DESIGN REVIEW & EXCELLENCE PANEL RESPONSE REPORT

14-16 MARSHALL AVE, 2-10 BERRY RD & 5-9 HOLDSWORTH AVE, ST LEONARDS

DEVELOPMENT APPLICATION

May 2023

4.12 12 Street activation

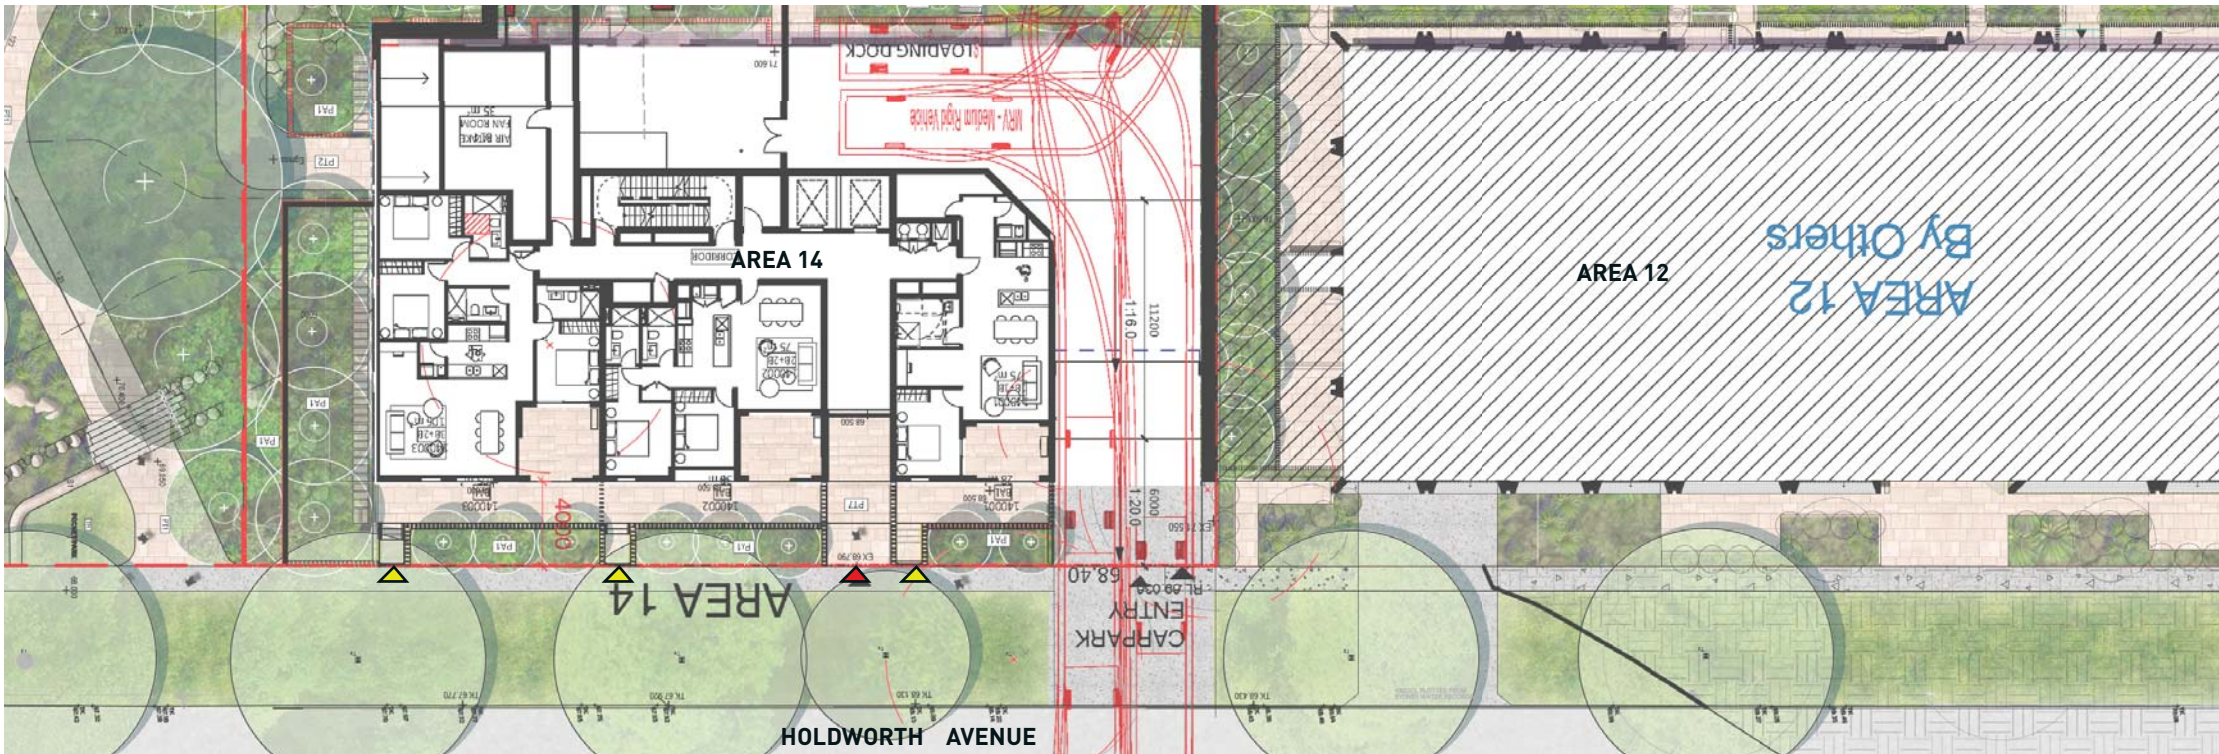
The general approach to increasing street activation is acceptable. However the garden entrances on Marshall Avenue require further development including demonstration of gates and fences etc.

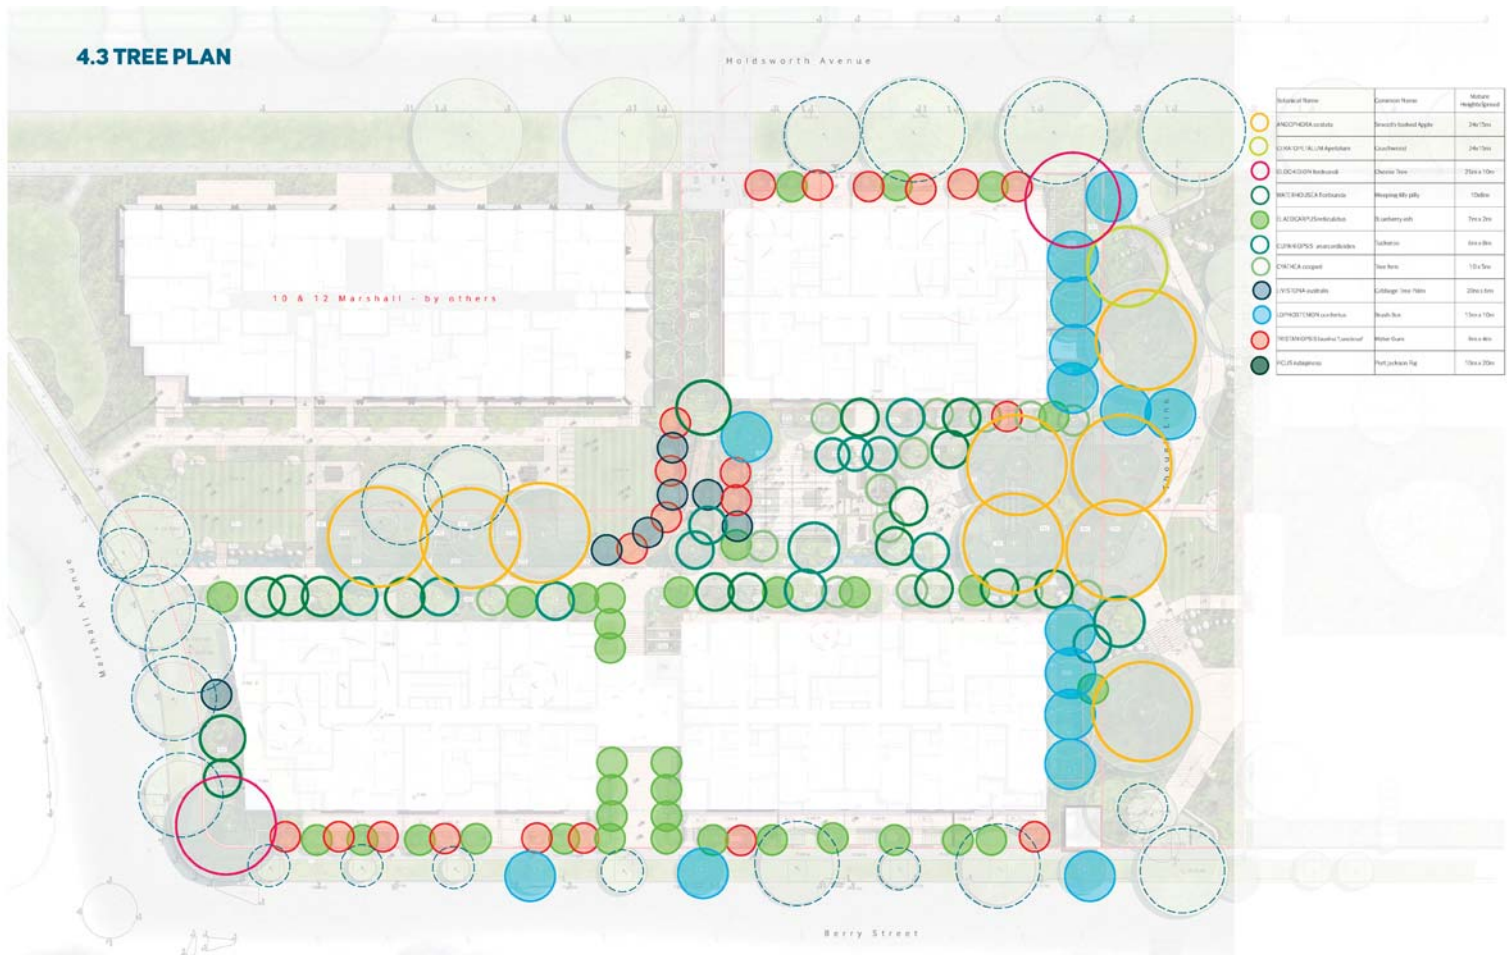
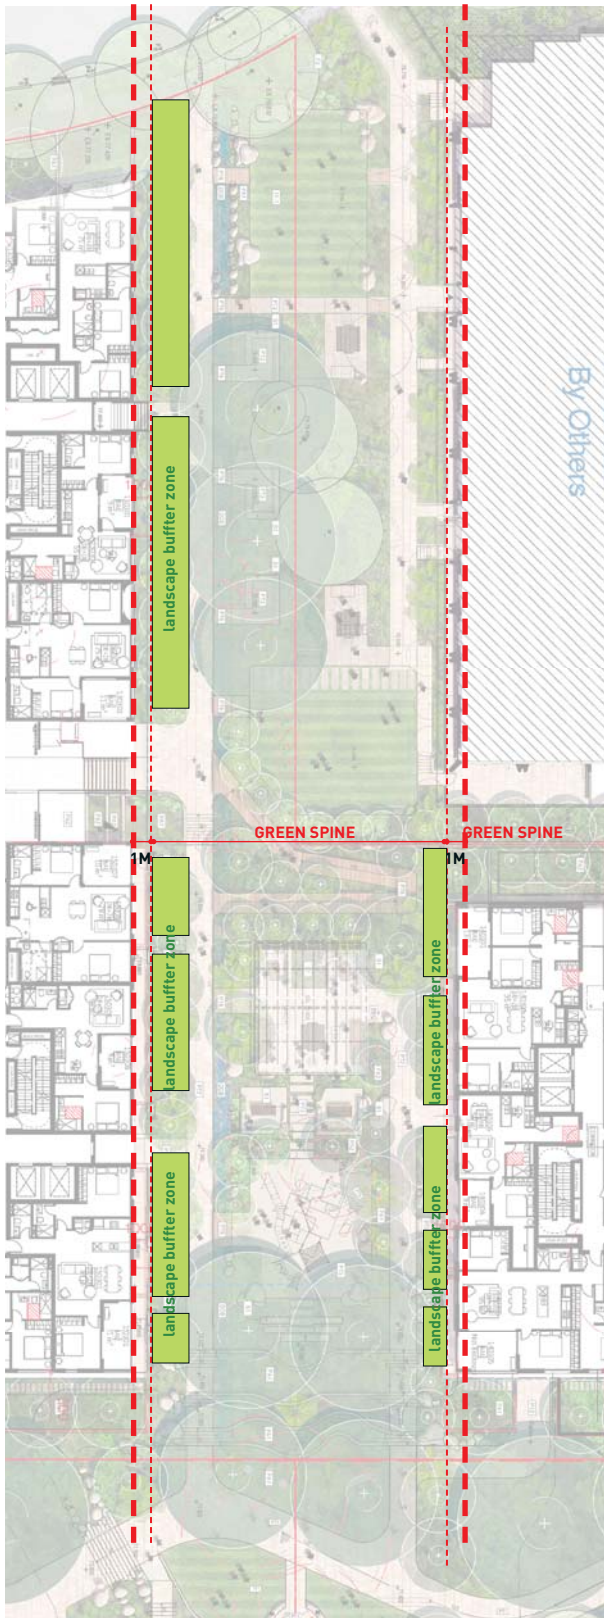
The expansion of private courtyards into the green spine by 1 m is acceptable, however, more detail design should be provided to indicate how planting is resolved to provide privacy to residents whilst retaining passive surveillance.

Provide landscape buffer zone between the expansion of private courtyard and green spine to improve the units' privacy condition.

4.12 16 Corridor privacy

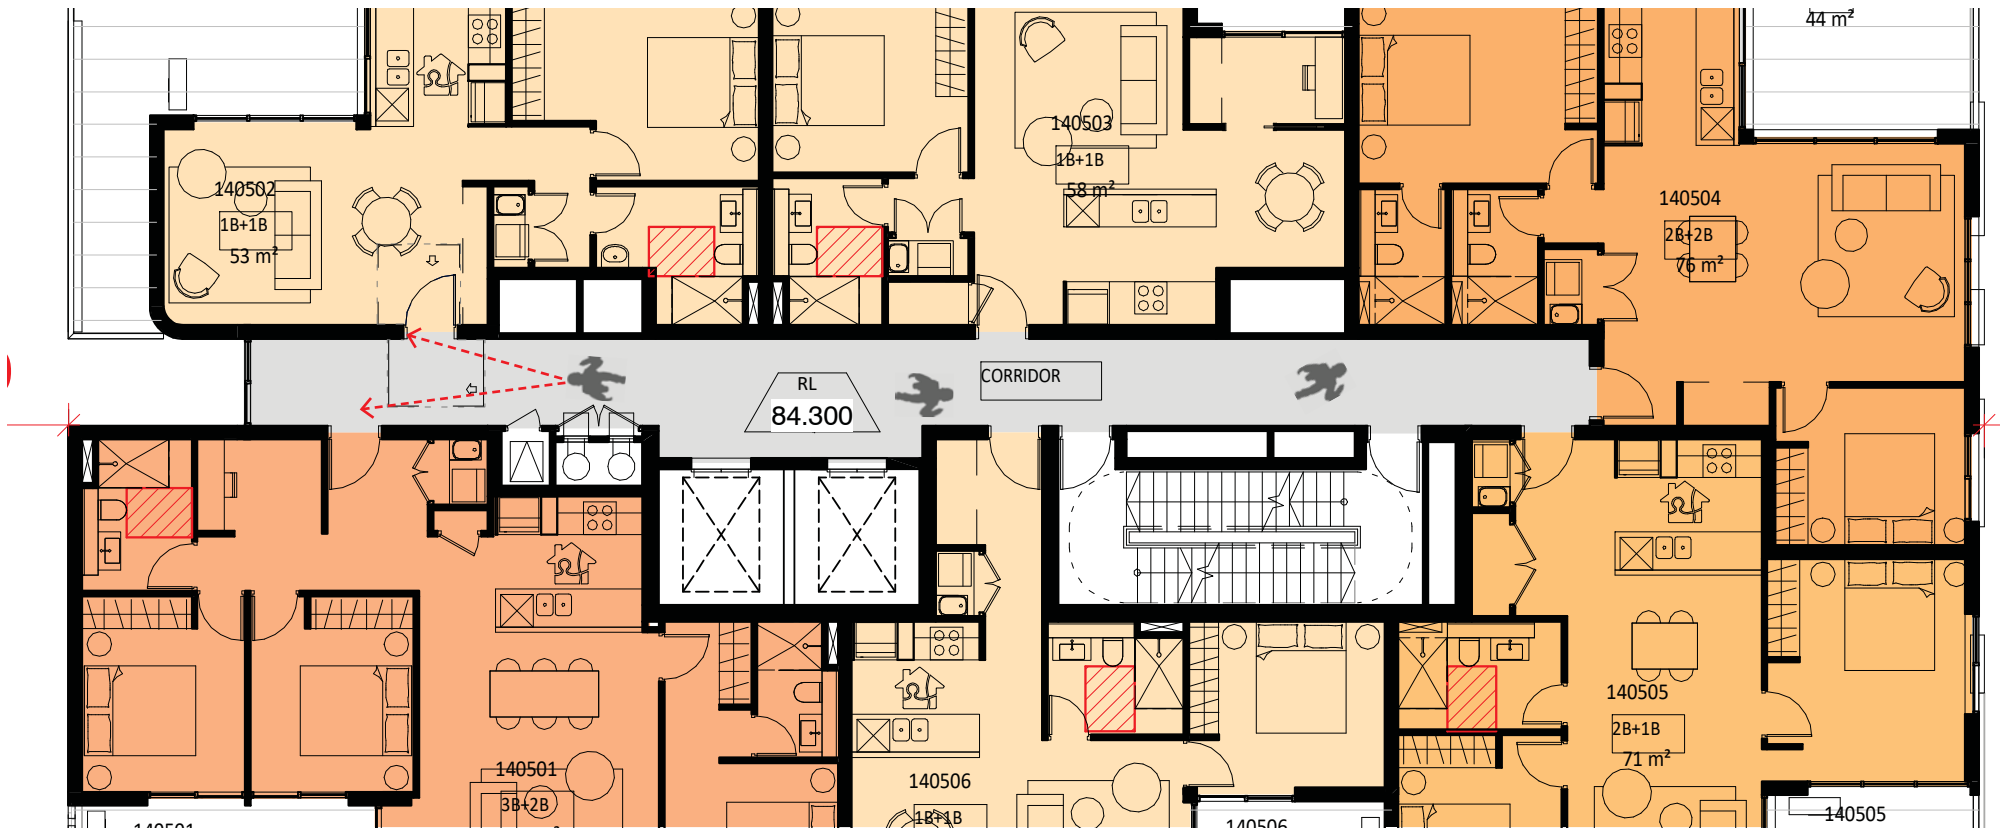
Issues remain with cross-looking and acoustics into apartments, for example between living rooms in apartments 140501 and 140502. The adjacency of entry doors between apartments such as 140504 and 140505 should also be reviewed.

The apartment layouts have been reviewed and revised to reduce cross-looking and undesirable noise into other apartments.

Particular detail is considered to apartments 140501 and 140502 to avoid cross-looking into each living space by revising the internal layout and offsetting the entry doors.

The entry door to apartment 140504 has been provided with a joinery cupboard to provide some screening from the main entry.

- AREA 14 _ EAST-WEST SECTION

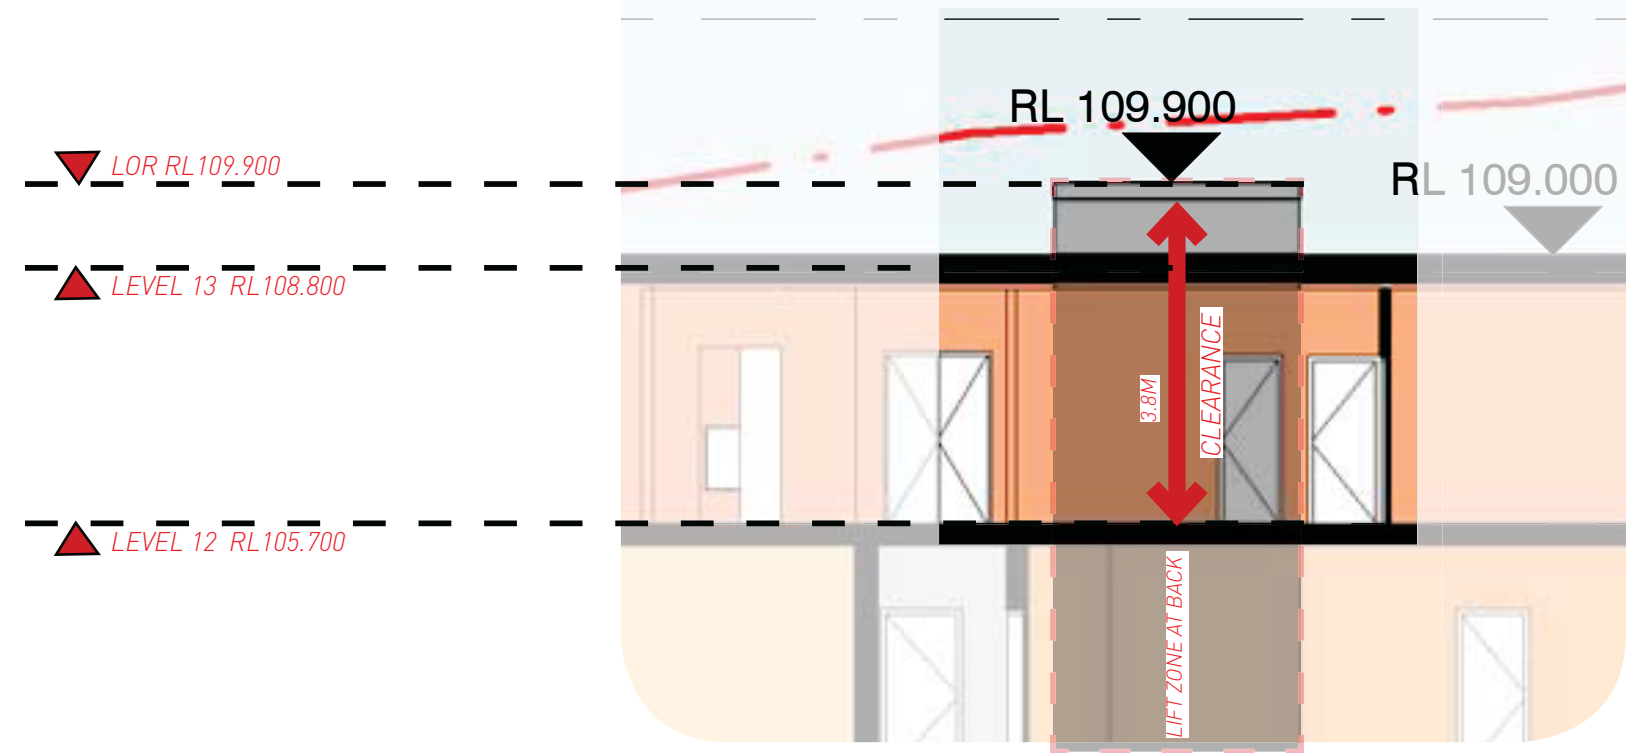
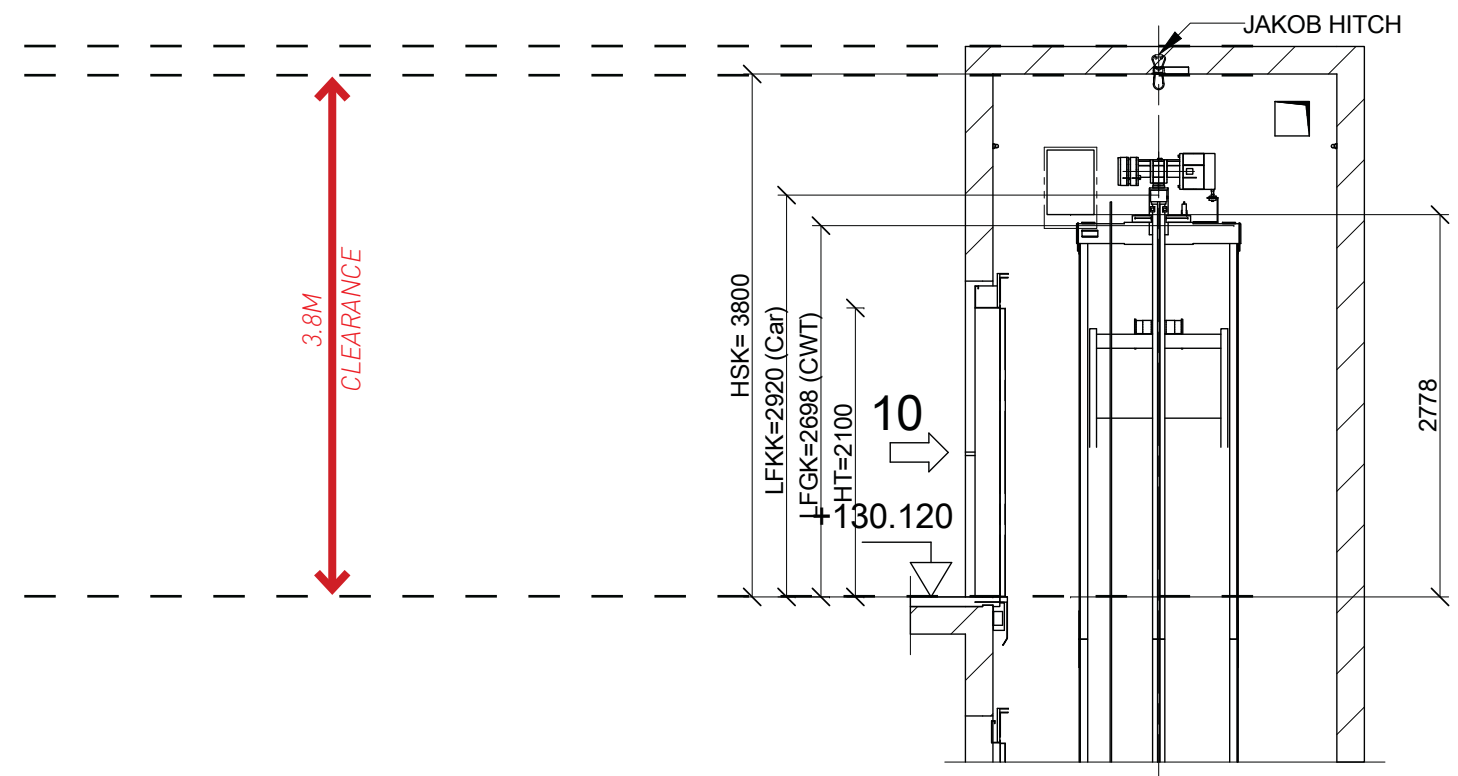
The height compliance for the Building 14 lift motor rooms, noting a minimal over-run is shown on the drawings

The built form corresponds to current solutions available in the lifts market for lower lift over runs and the proposed design intent is therefore compliant to industry standards of operability. And the lift overrun is below the height limit.

4.12 ITEM 14

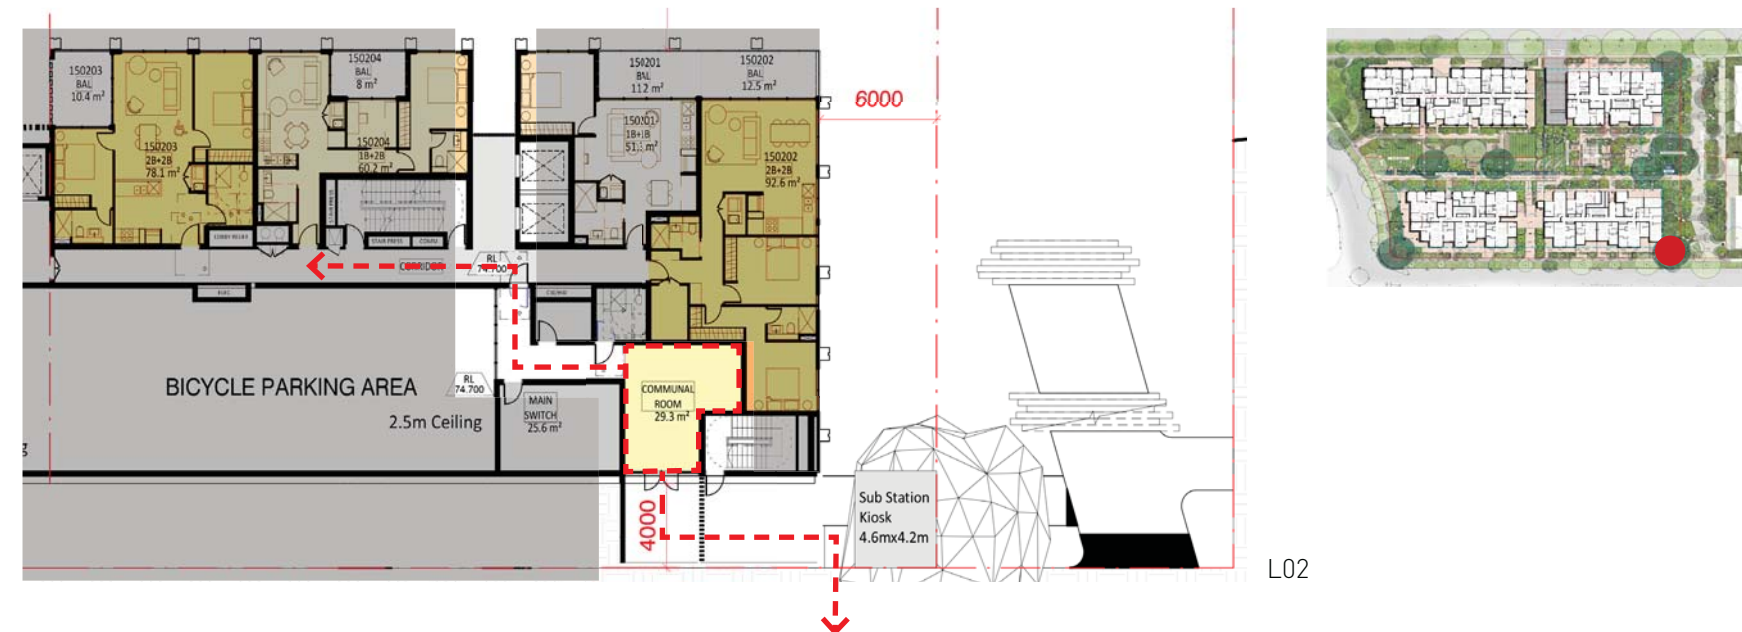
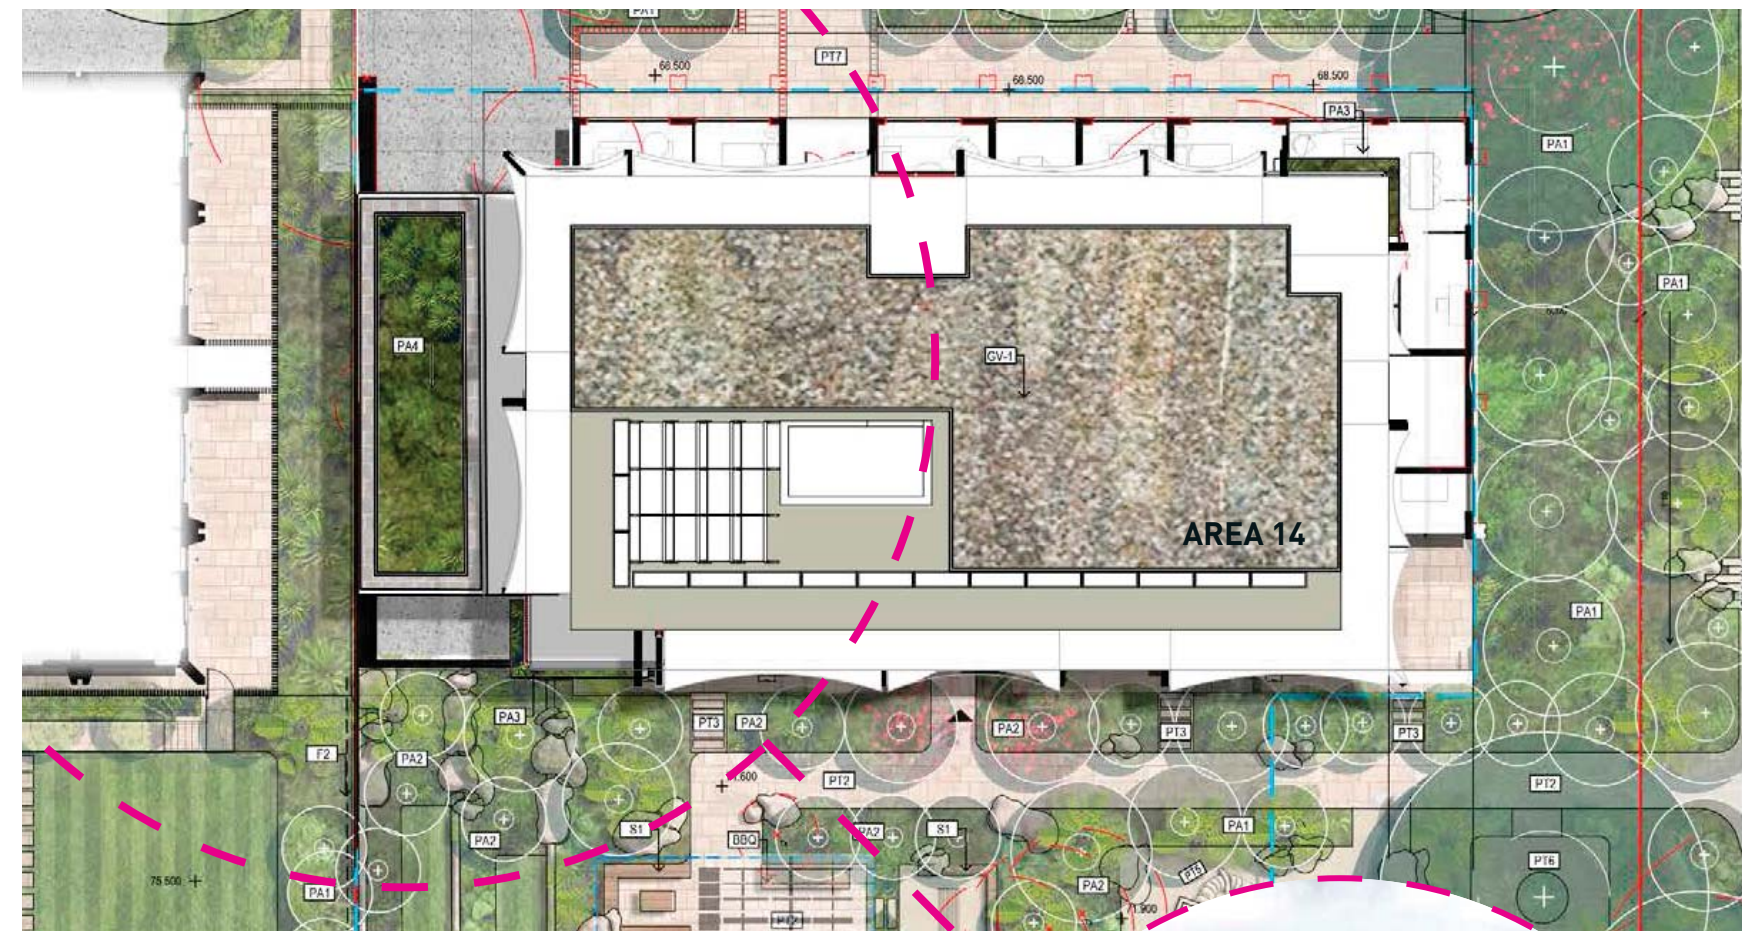
Reinstate the indoor communal facilities and roof terrace to Building 14 included in the pre- DA design proposal presented in May 2021, consistent with the St Leonards South Landscape Masterplan Sustainability Design Principles and Private Open Space Typologies - Roof Gardens and St Leonards South DCP 7.4 Private Domain and 8.3 Green Roofs.

The overall design intent seeks to allow for a permeable well integrated communal open space interface for all units facing the central green spine. In alignment with the St. Leonard’s South DCP provision on private courtyards at ground level, the current design enables all private open spaces to extend into the central green space by a distance of 1m. In doing so, the design intent is to allow for an active central green spine, that in turn would provide for a socially vibrant community of living. Simultaneously, this design measure allows all ground level private open spaces enhanced solar access, thereby improving the overall amenity of the units.
